PERMIT

ON-SITE SEWAGE DISPOSAL SYSTEM HOWARD COUNTY HEALTH DEPARTMENT BUREAU OF ENVIRONMENTAL HEALTH

SUBDIVISION: Highland Overlook LOT NUMBER: 30

ADDRESS: 6820 Green Hollow Way PROPERTY OWNER: Running Brook LLC

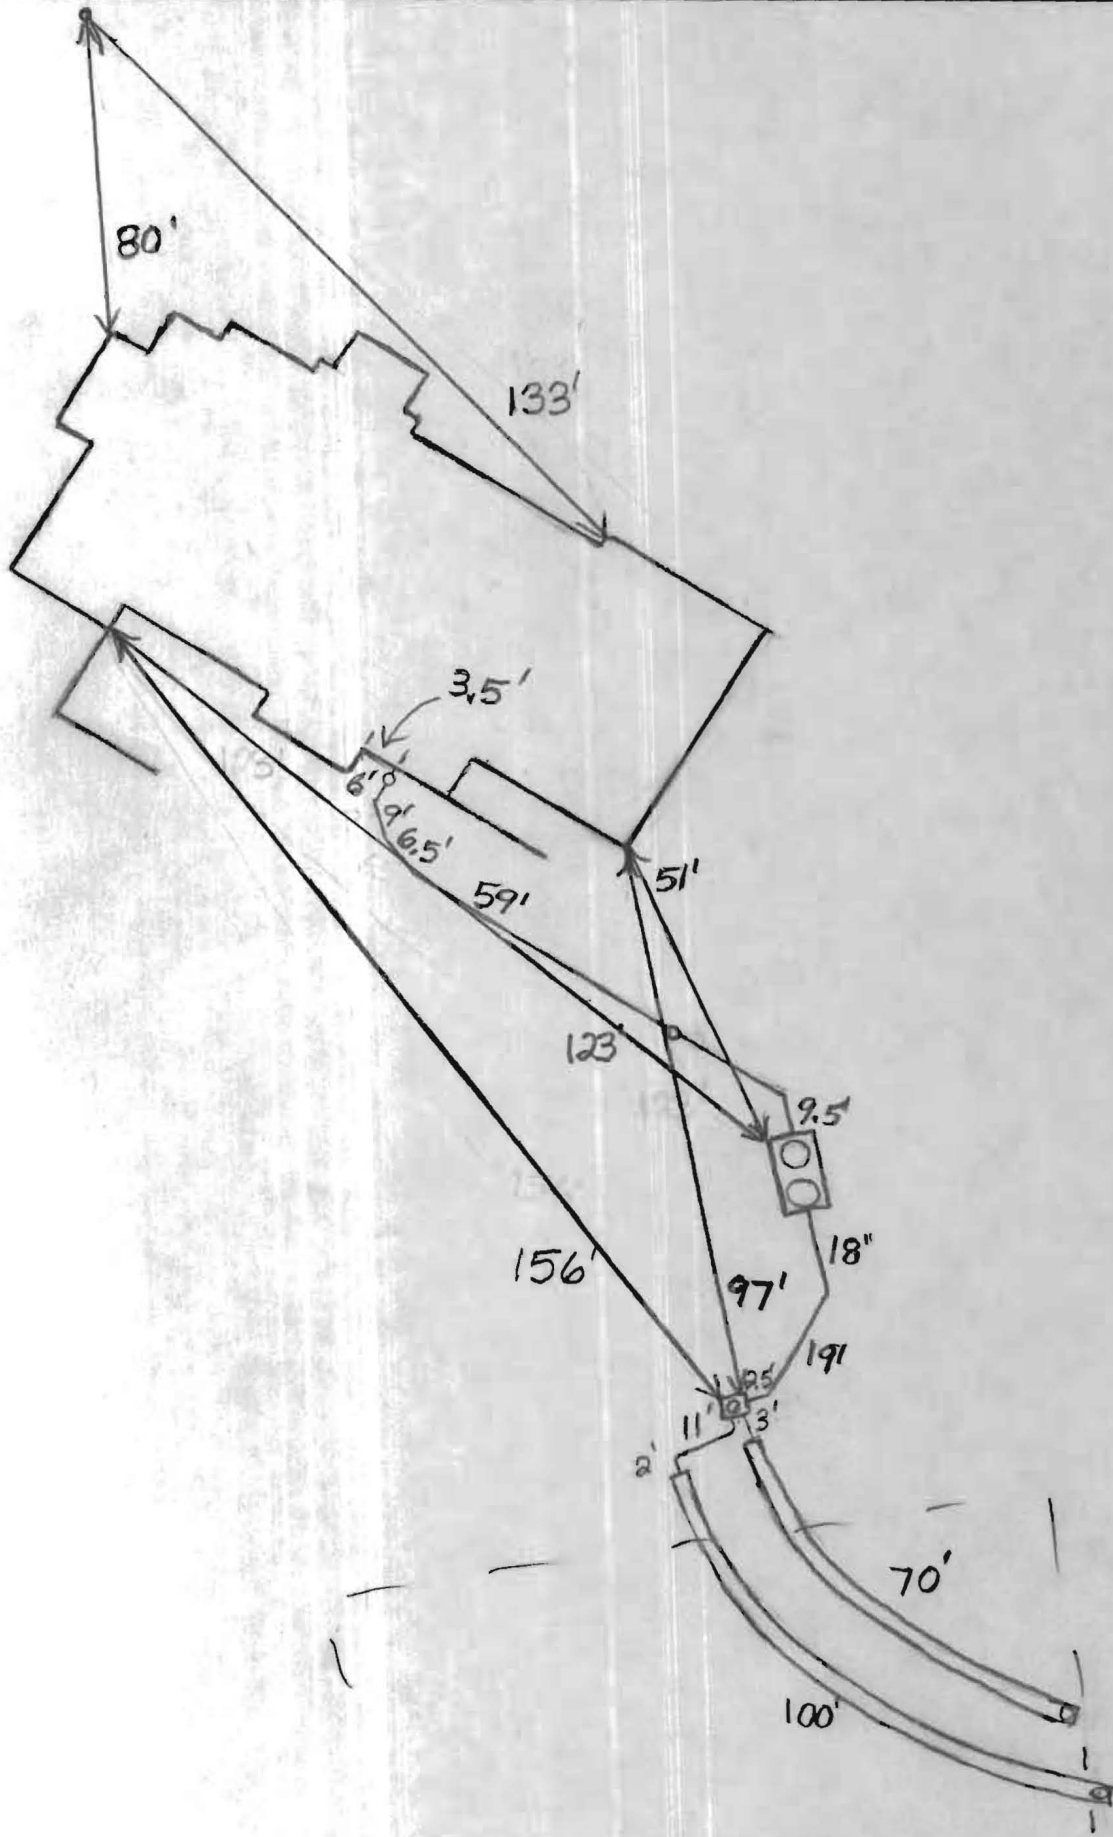
PRE-CONSTRUCTION 3/24/08. Install a 70' trench on contour as high as possible in the easement and a 100' trench on contour directly below it. (BB) 3/25/08
 INSTALLATION Plumbing to box done. Tank set. Top 70' trench done. (BB)
 3/26/08 System finished. O.K. to backfill. (BB)

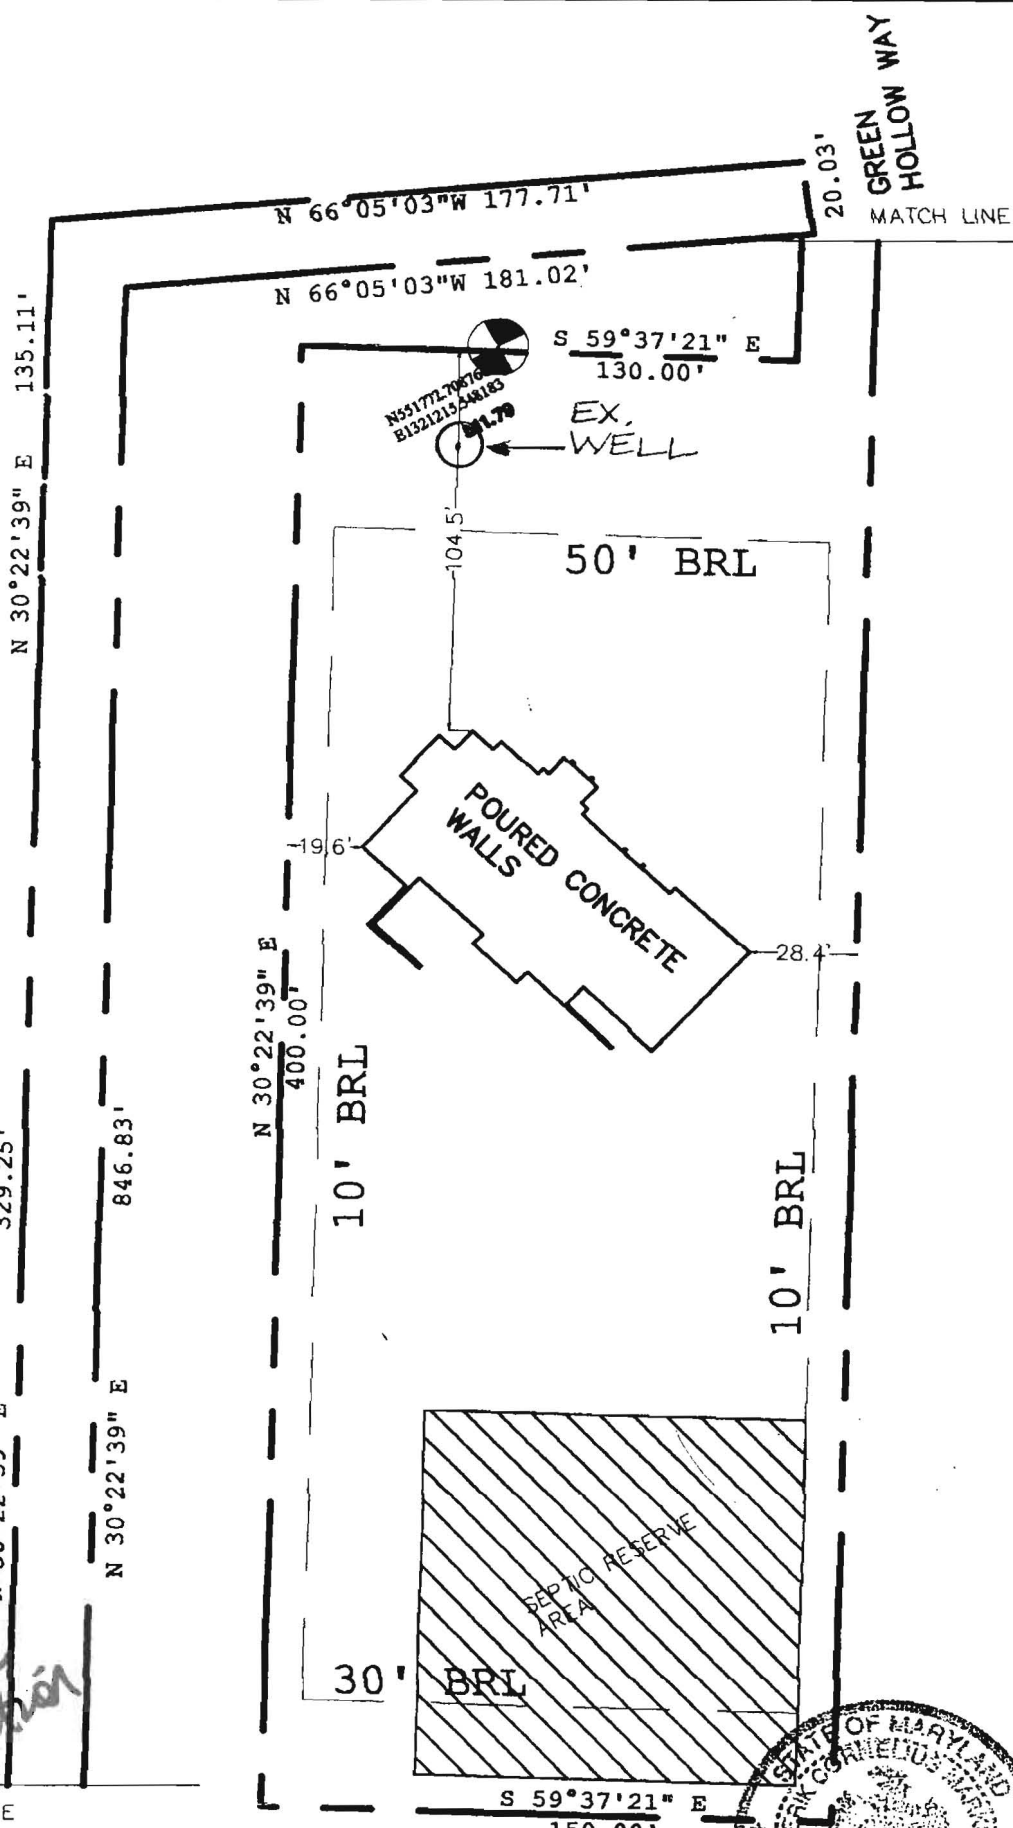
*walk check
ok
3/21/08
gs
house shifted
southeast
direction*
